Access Compliance Report

Public Rights-of-Way

(Curb Ramps)

Intersection ID: 51503	Main Street: EASTFIELD_PARK_DR	Cross Street: EASTFIELD_RD	Location: S
ADA ID: D6928485BF60	Ramp Type: Perp	Initial Pass/Fail: Fail	Overall Compliance: No
Codes/Mitigation Info/Possible Solution		Field Measurements/Component Compliance

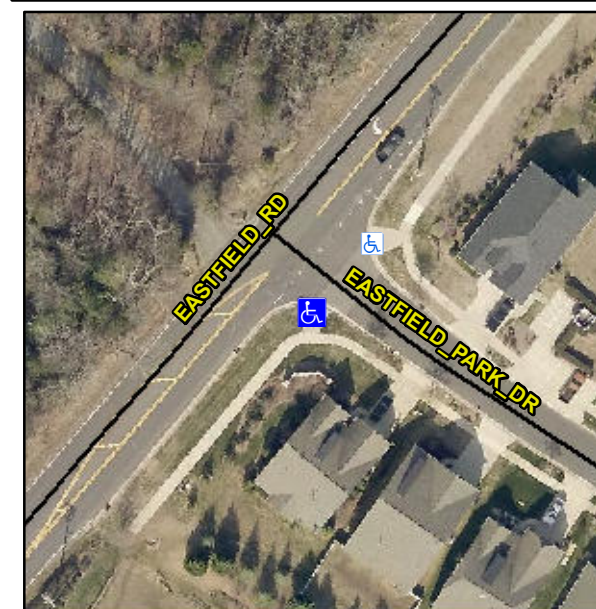
R304.2.2, R304.5.3

Compliance	Description	Data	Compliance	Description	Data
N/A	Ramp Length (in)	167.0	No	Ramp Slope (%)	8.5
Yes	Ramp Width (in)	48.0	No	Ramp XSlope (%)	4.8
N/A	Flare Type LT	N/A	N/A	Flare Type RT	N/A
N/A	Flare Slope LT (%)	N/A	N/A	Flare Slope RT (%)	N/A
N/A	Flare Traversable LT?	N/A	N/A	Flare Traversable RT?	N/A
N/A	Landing Length (in)	N/A	N/A	DWS Provided?	N/A
N/A	Landing Width (in)	N/A	N/A	DWS Contrast?	N/A
N/A	Landing Slope (%)	N/A	N/A	DWS Length (in)	N/A
N/A	Landing X Slope (%)	N/A	N/A	DWS Full Width?	N/A
N/A	Landing Curb? (Y/N)	N/A	N/A	DWS Offset (in)	N/A
N/A	Shared Landing?	N/A			
N/A	Gutter Ponding?	N/A	N/A	Gutter Slope (%)	N/A
N/A	Gutter Lip Ht (in)	N/A	N/A	Gutter X Slope (%)	N/A
N/A	Painted X Walk1?	No	N/A	Painted X Walk2?	N/A
	X Walk 1 Direction	To NE		X Walk 2 Direction	N/A
N/A	X Walk 1 Width (in)	N/A	N/A	X Walk 2 Width (in)	N/A
	X Walk 1 Slope (%)	1.5		X Walk 2 Slope (%)	N/A
	X Walk 1 X Slope (%)	5.1		X Walk 2 X Slope (%)	N/A

Remove & Replace Entire Ramp.
